Product Repair Bulletin

P/N 3844020 / 3844199 / 3613195

Heat Shield

NHA: GTCP331 Series APU

VIEW C-C

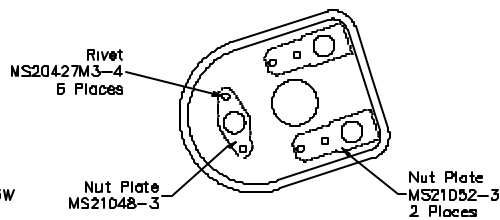
PRE S/R 49-5811
TYP 4 PLACES

POST S/R 49-5811
TYP 4 PLACES

- Procure MS21052-3 nutplate per S/B 49-5811.(4)
- Procure MS21048-3 nutplate per S/B 49-5811.(8)
- Procure MS20427M3-4 rivet per S/B 49-5811.(20)
Converts 3844020-3 to -6; 3844199-1 to -2; 3613195-1/2/3 to 4/5/6;
- Procure 3614949-1 heat shield seal per S/B 49-5968.
*Rework heat shield P/N 3844020-1/2/3/4/5/6, P/N 3844199-1/2 or
P/N 3613195-1/2/3/4/5/6 by replacing heat shield seal,
P/N 3844056-1/-2 with P/N 3614949-1.*
- Remove baffle per S/B 49-6972.
Converts 3844199-2 to -3.
